CITY OF HOUSTON

21119664

Reference:	<u>Address</u> 7802 Willow Street, Lot: 14 & 15, Block: 12 Highland Addition, L14/12 - Houston, Texas	<u>Plan No.</u> A Option 2 <u>Design Code</u> See Plan
-------------------	---	---

NEW HOME DEVELOPMENT PROGRAM
HIGHLAND ADDITION - HOUSTON, TEXAS
LOTS: 14 & 15 BLOCK: 12
PLAN: "A" SERIES - OPTION 2
7802 WILLOW STREET
DESIGN CODE: 1024

01 SITE PLAN

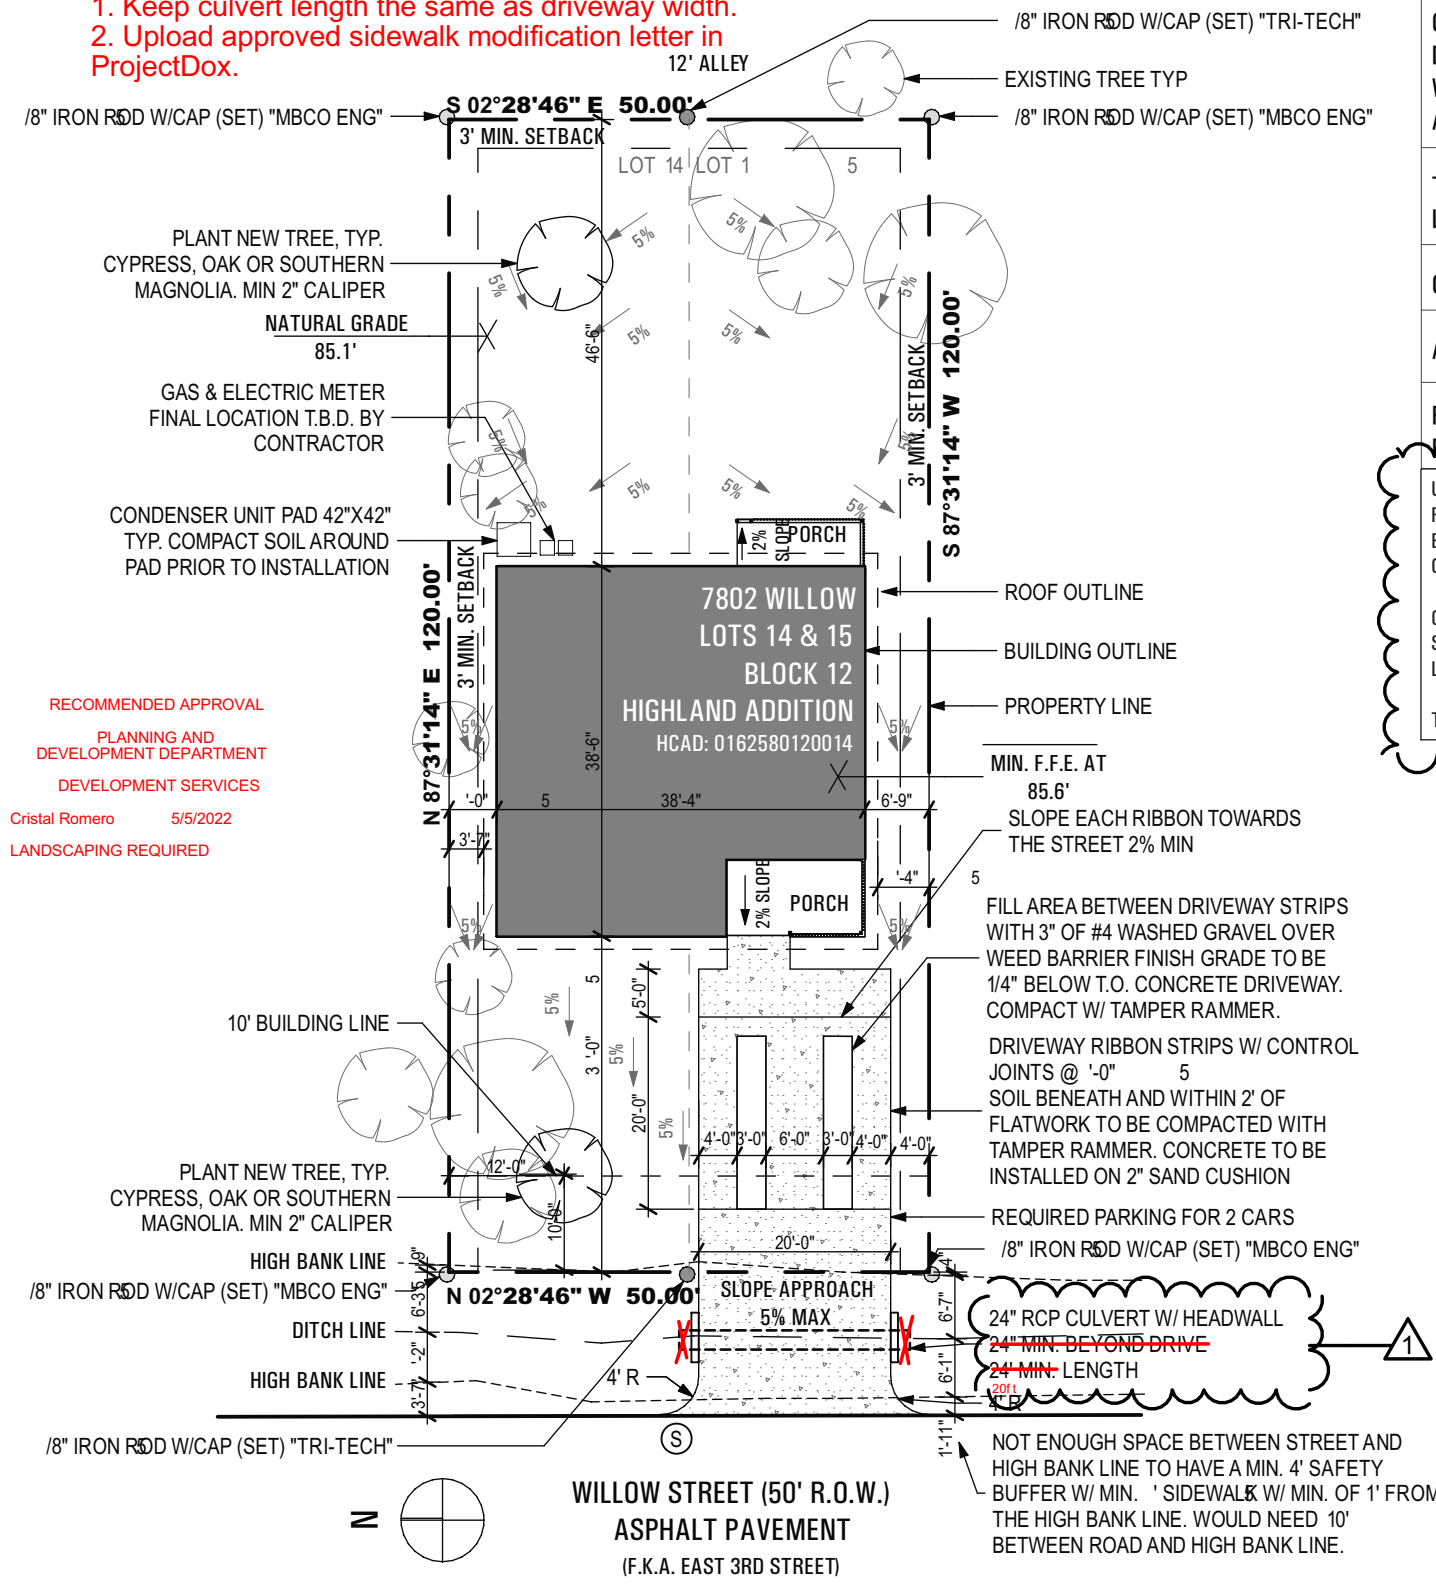
- 1. Keep culvert length the same as driveway width.
2. Upload approved sidewalk modification letter in ProjectDox.
